# Proposal to make Energy detect more robust in 10GBASE-KR EEE mode.

Velu Pillai  
17<sup>th</sup> November, 2009

# CL49 LPI transmit state diagram changes (Fig 49-16)

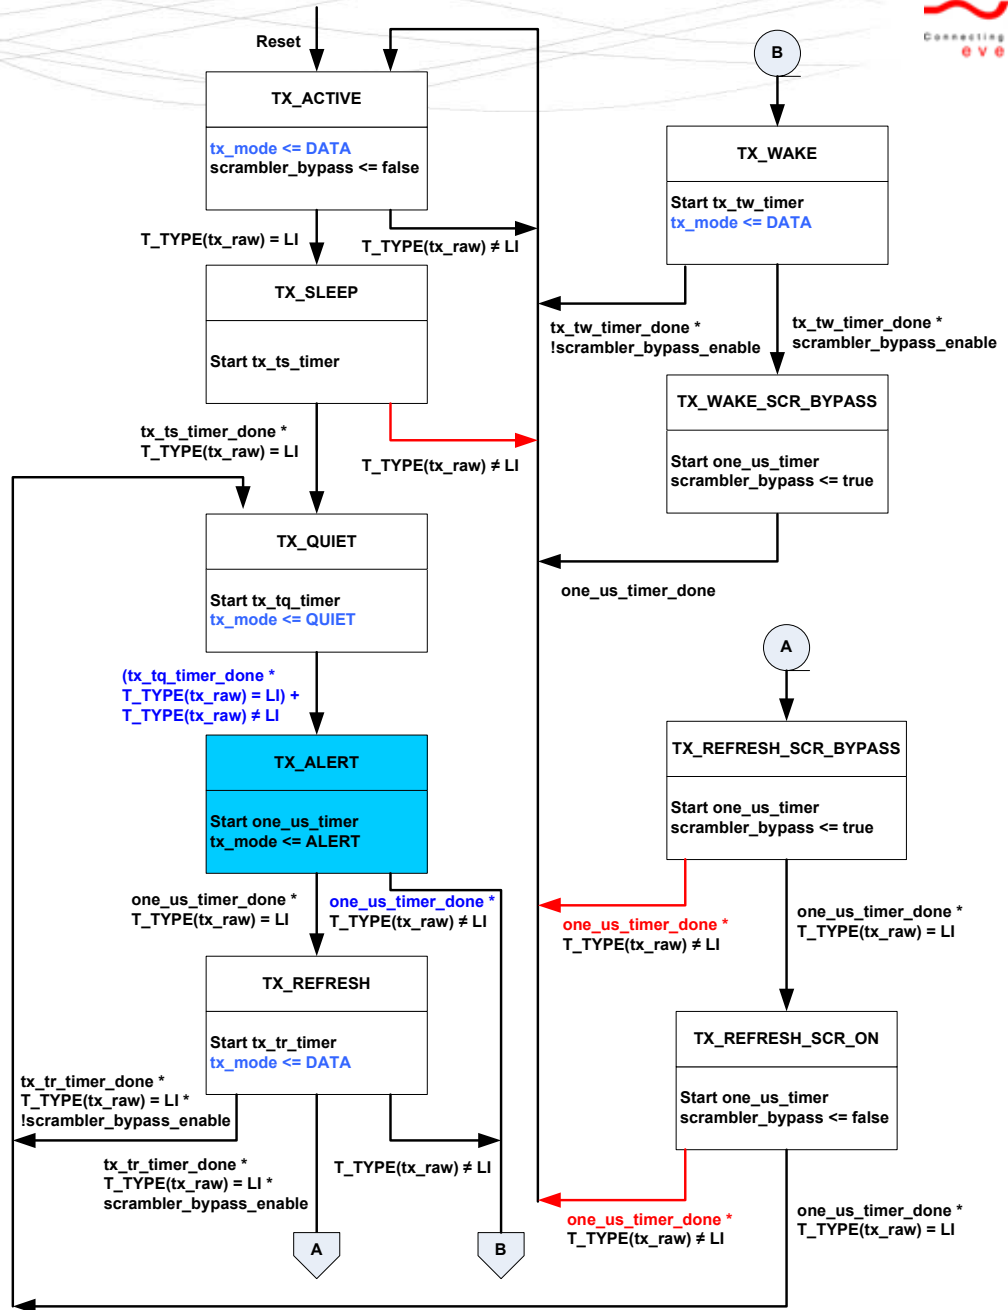
- Solutions to the bugs in the Fig 49-16 (Draft 2.1). Comments are filed against these.

- Changes needed for alert pattern.

*Rename "tx\_quiet" to "tx\_mode". That way we can avoid adding a new variable and service interface.*
